City of Portland, Maine - Building or Use Permit Application

BUILDING PERMIT REPORT

REASON FOR PERMIT: Replace shed / Front stoop / STAIRS / Front door

Re: Certificate of Appropriateness; 31 Taylor Street—exterior and site alterations

FRONT STOOP + STAIRS

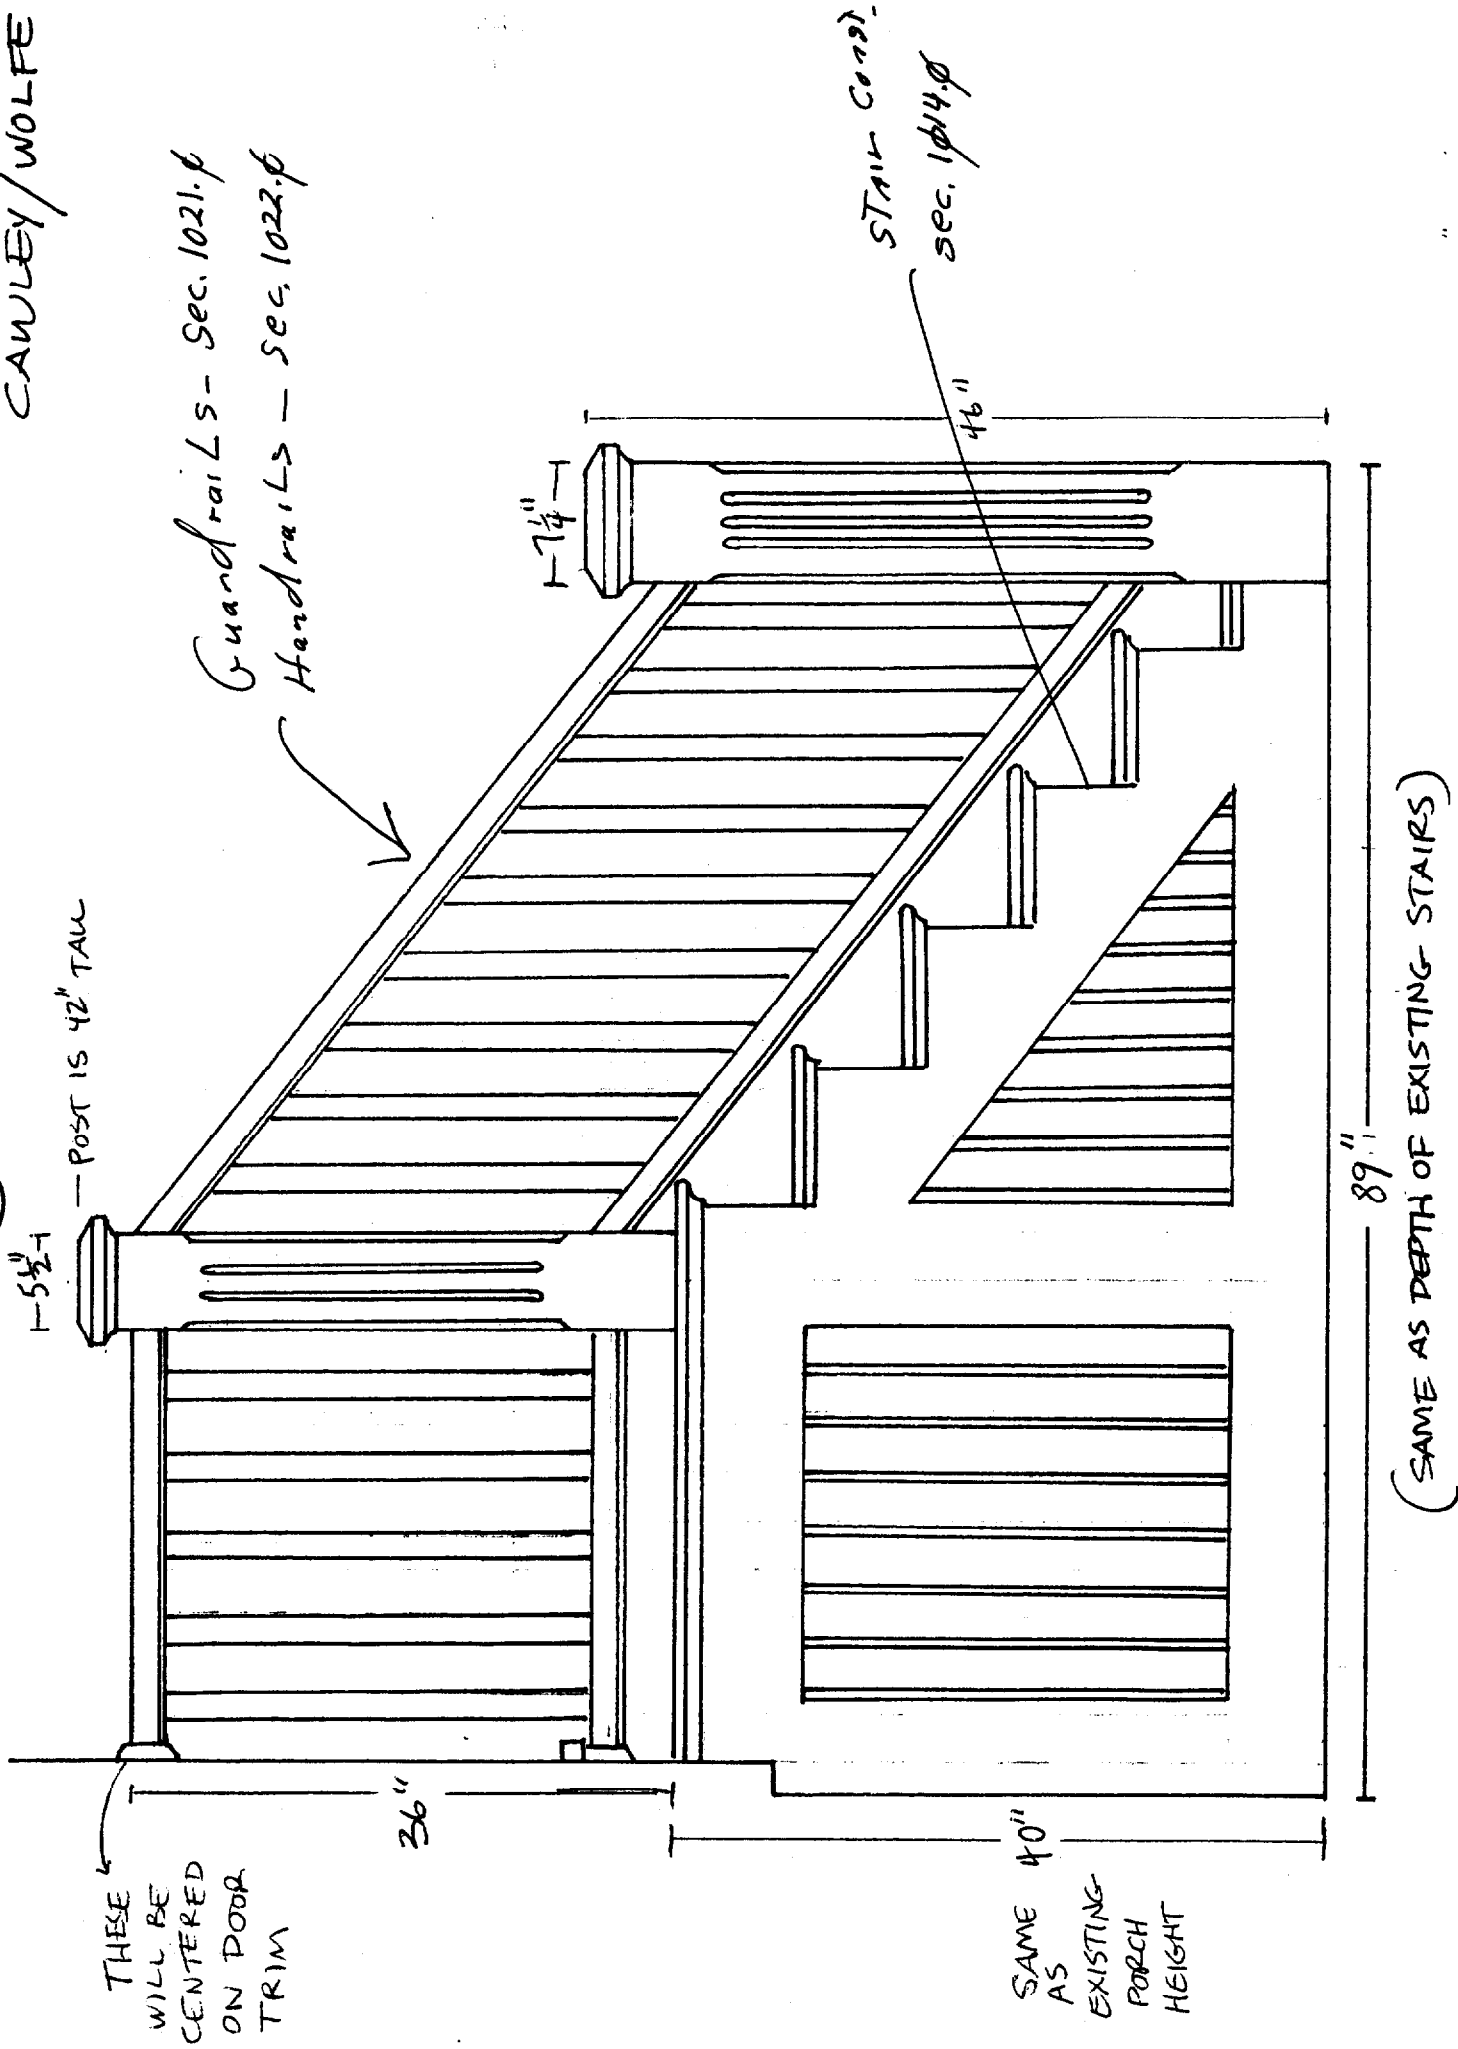
3. The distance from the porch deck to the ground: 40"

5. The current railing height and/or documented original railing height: CURRENT = 33", NOT RELEVANT
BECAUSE NO RAILING ORIGINALLY (SEE 1924 PHOTO)

6. The railing height requested: 36", BASED ON HEIGHTS OF OTHER SIMILAR
FRONT ENTRYWAYS IN NEIGHBORHOOD/HISTORIC DISTRICT

The rail height on our design is 36 inches, which is three inches higher than what's on there now — we have a railing height code exemption certificate (see attached copy).

H.P. staff supports request -
appropriate to scale of house - J. Andrews

36" STAIRS & LANDINGS
SHOULD BE OK (CJG)
